**Report to the Future Melbourne Planning Committee**

**Planning Application: TP-2016-1124/A  
Queen Street Road Reserve and Queen Victoria Market, 65-159 Victoria  
Street, Melbourne**

**3 April 2018**

## PLANNING APPLICATION REPORT

01 NORTH ELEVATION (VICTORIA ST) 1:200

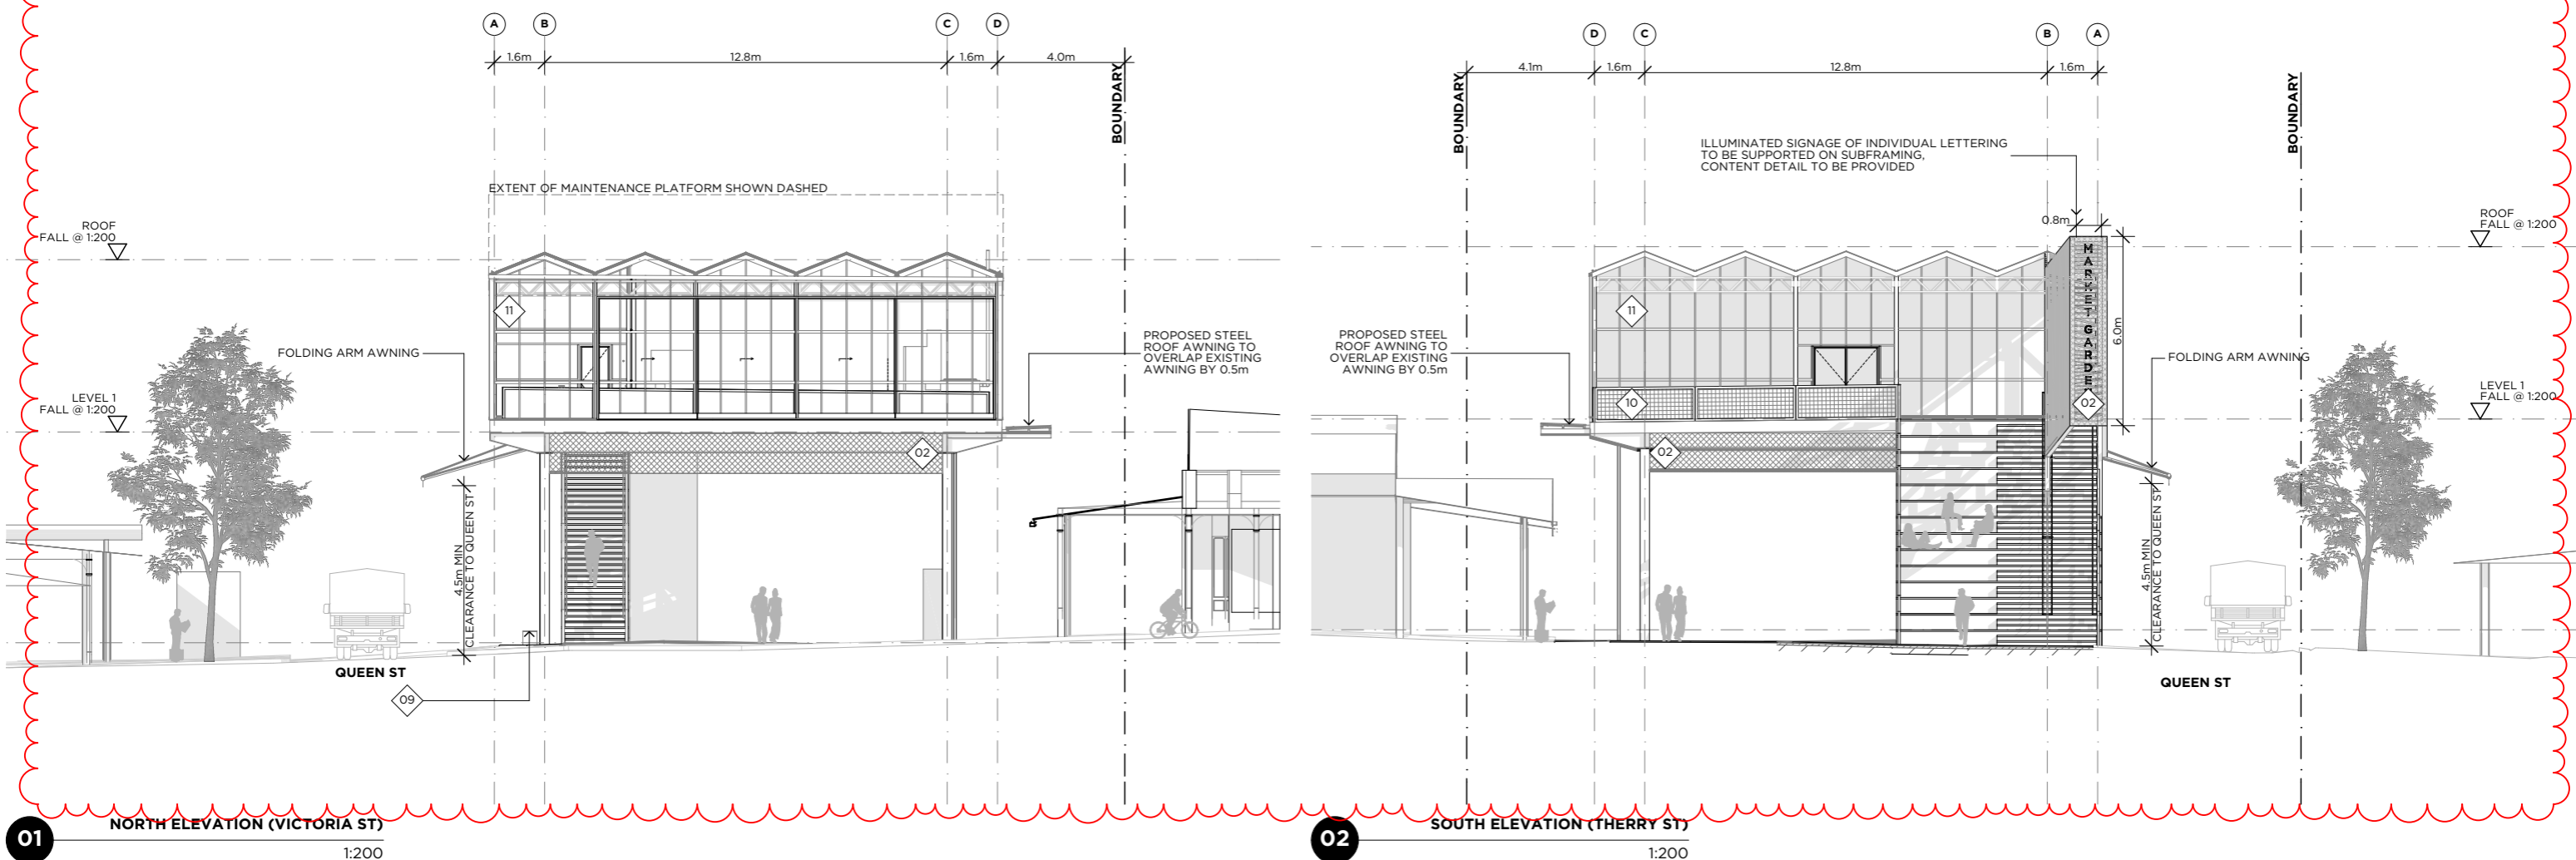
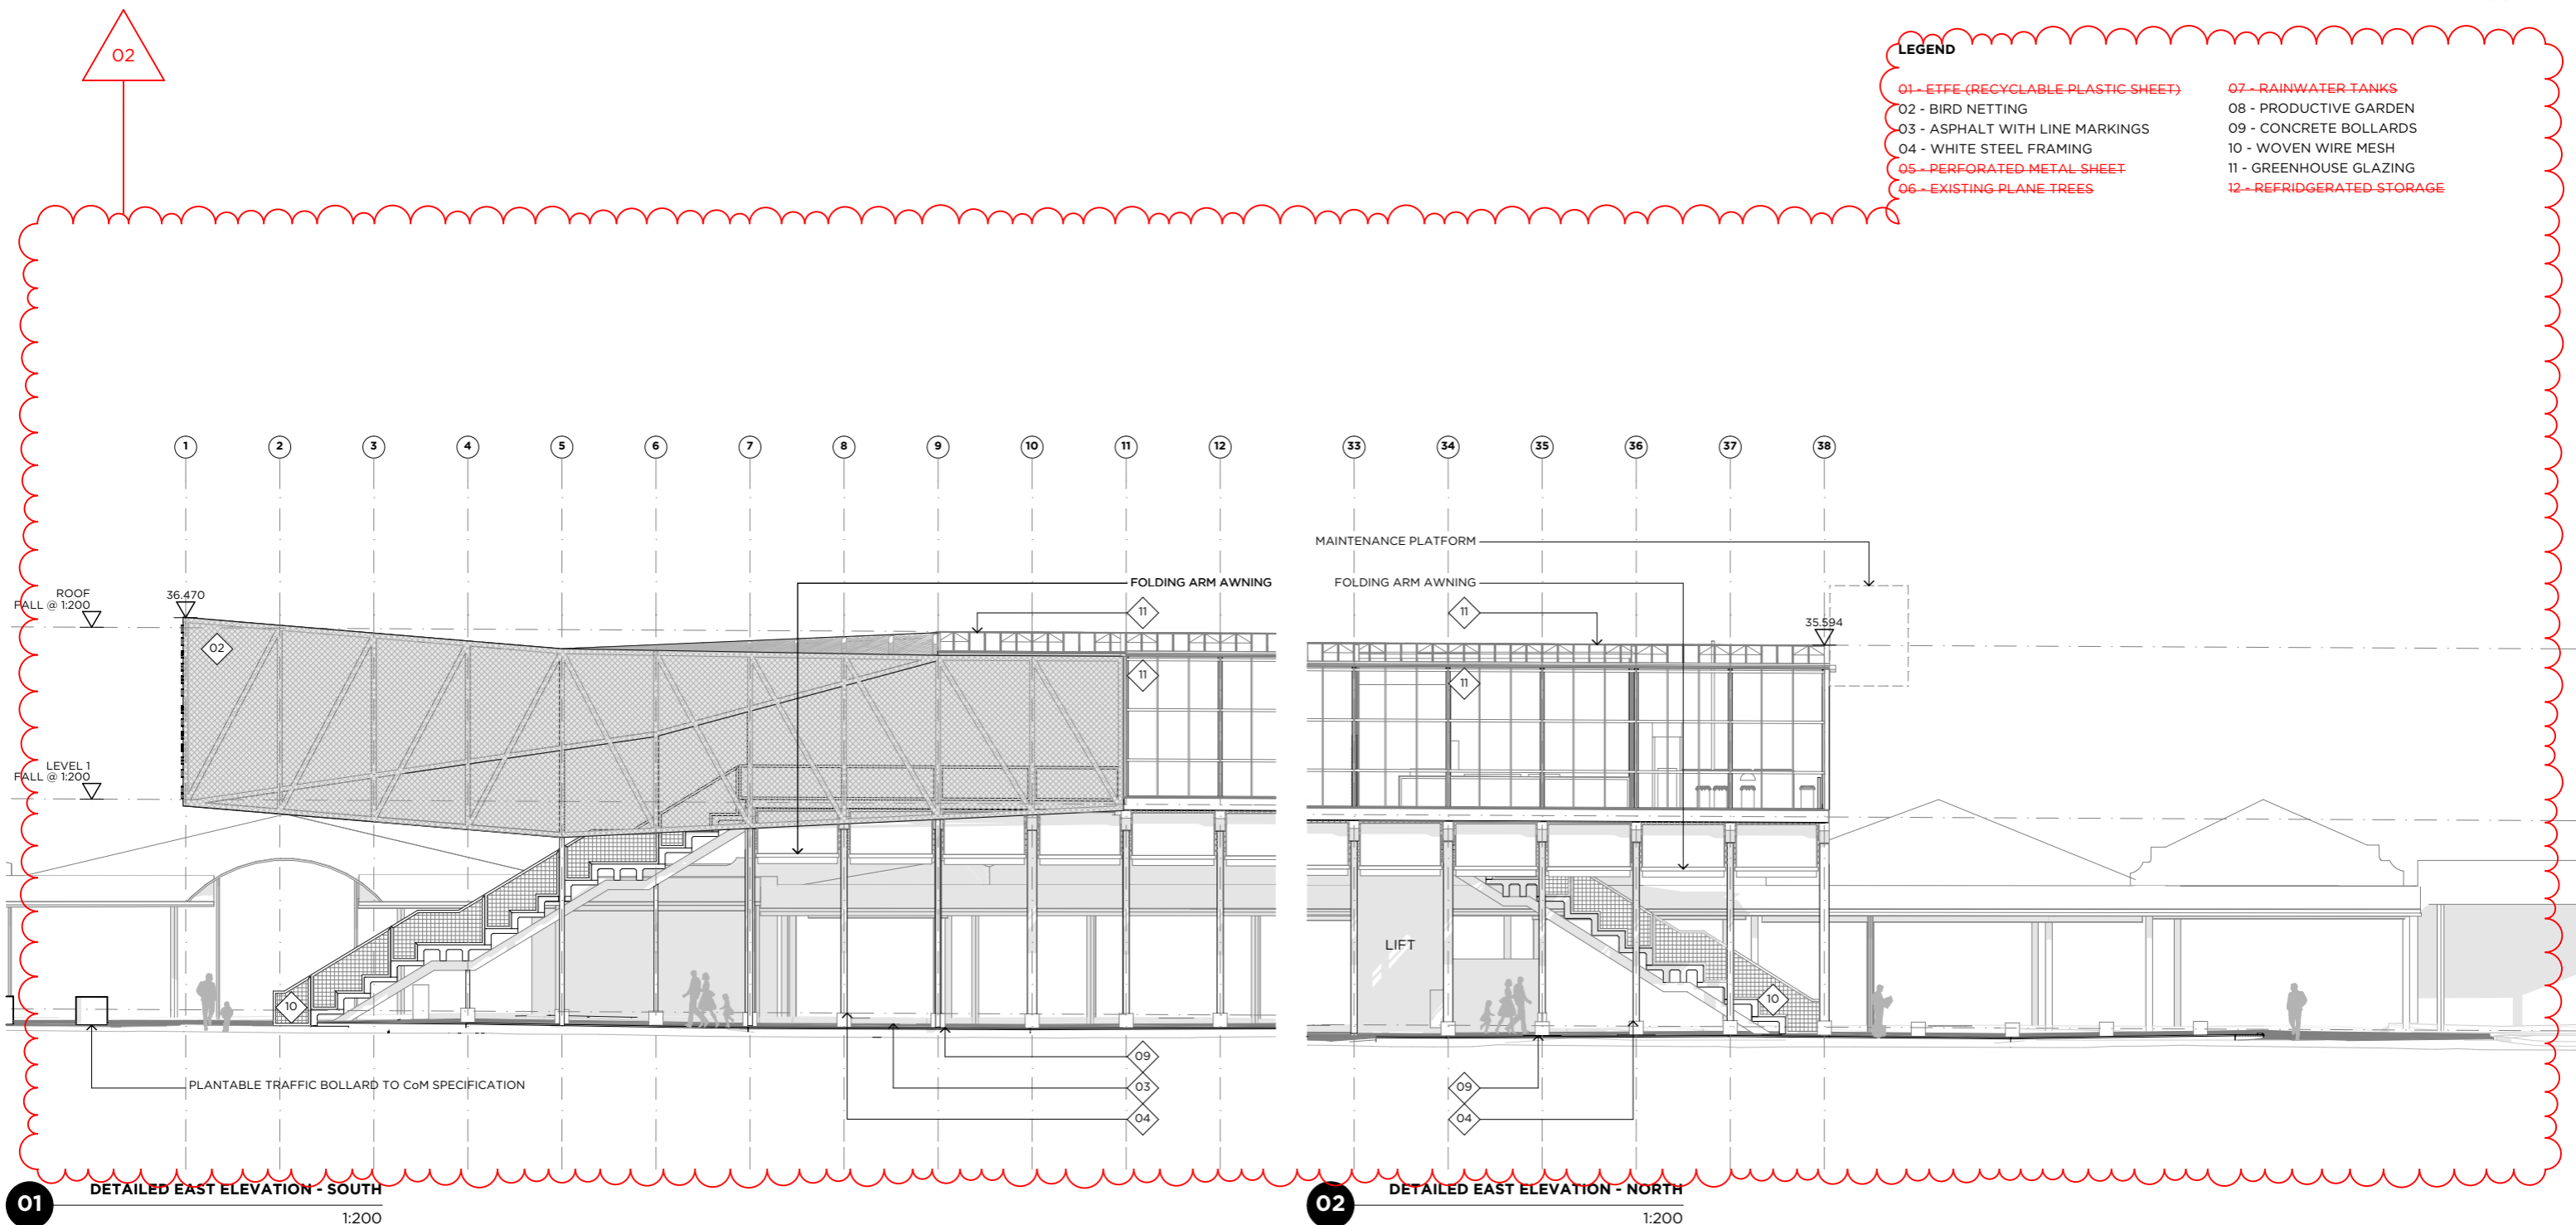
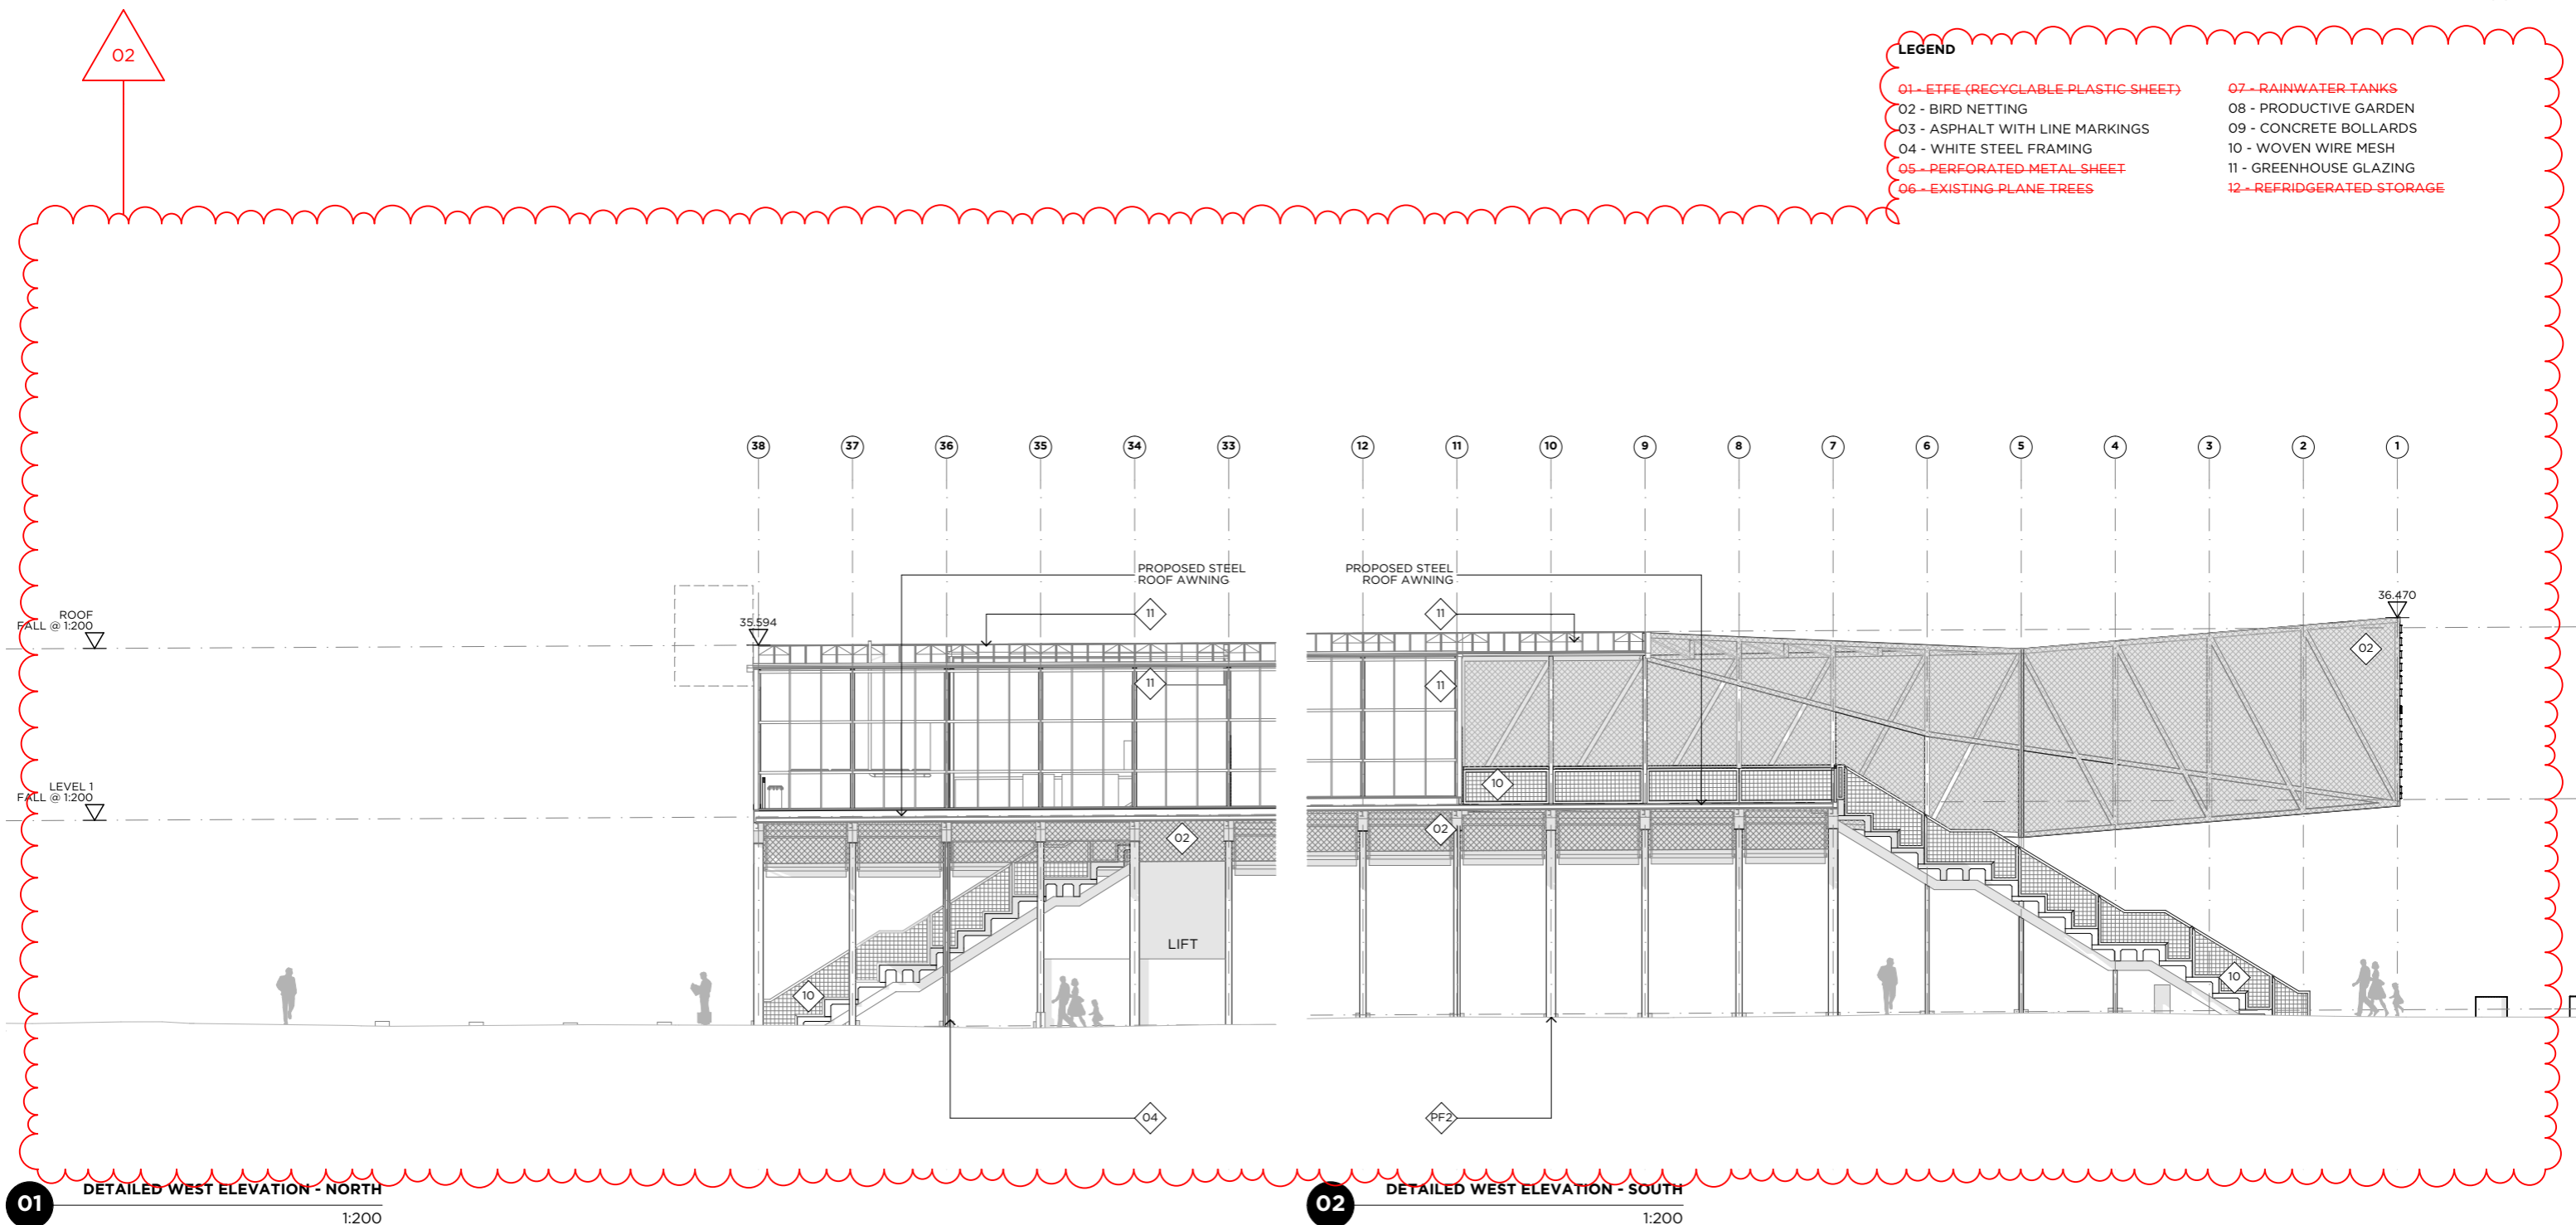
*The revised proposal is a reduction in the scope of the project, including the length of the structure, as well as some of the previous design resolution. We recognise the rationale for the reduction in size due to changed functional requirements but this has impacted on the success of the design strategies. We encourage further consideration of how they could be addressed in the detailed design stage. These include:*

*We note a revised landscape plan has not been reviewed within the application package, although it is noted within the architectural drawings. While acknowledging the reasons for removal of the plane trees, it will significantly change the character of the area and integration of the structure into its setting, and we seek further evidence that an integrated landscape and built form response will be delivered.*

The applicant has responded to the Urban Design advice and noted that they would accept conditions of any amended permit to issue to require further detail in regard to improvements of the upper level to give it greater depth in elevation, the integration of further shading along the eastern elevation (the western elevation is constrained by smoke exit/fire engineering requirements) and further detail in regard to the provision of landscaping elements and built structures to be integrated into the proposal.

- d) Removal of 'Market Garden' signage on the southern side of the Western elevation.
  - e) **Amended landscape plan to reflect the modified design of the proposed pavilion.**

- f) **Revised upper level to achieve greater integration between the upper and lower form/level and to provide greater depth in the round.**
  - g) **Integration of further shading along the eastern side of the proposed pavilion.**

- h) **Detail of the location of movable planter boxes, flower containers, bollards and other structuring landscape elements to be integrated into the built structure and public realm.**

Figure Three: Extent of previously approved temporary market.

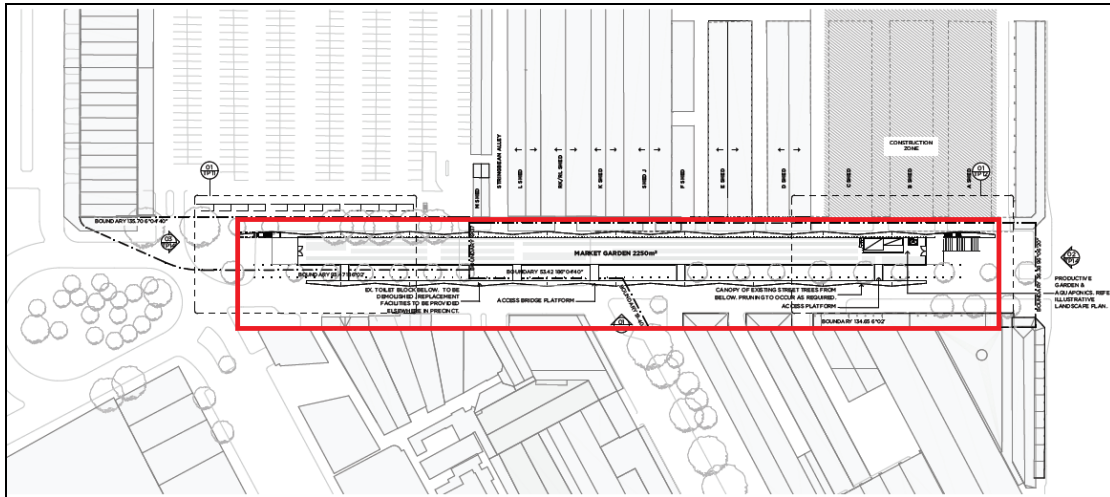
The approved pavilion had an overall length of 264 metres and a width of between 10 and 19 metres. The maximum height of the approved pavilion was 13 metres. The ground floor and had a floor area of 3,840 square metres with an additional 260 square metres for the back of house facilities. The first floor had a floor area of 2,250 square metres resulting in a Gross Floor Area of 6,350 square metres. The proposed amendment results in a significant reduction of the approved development.
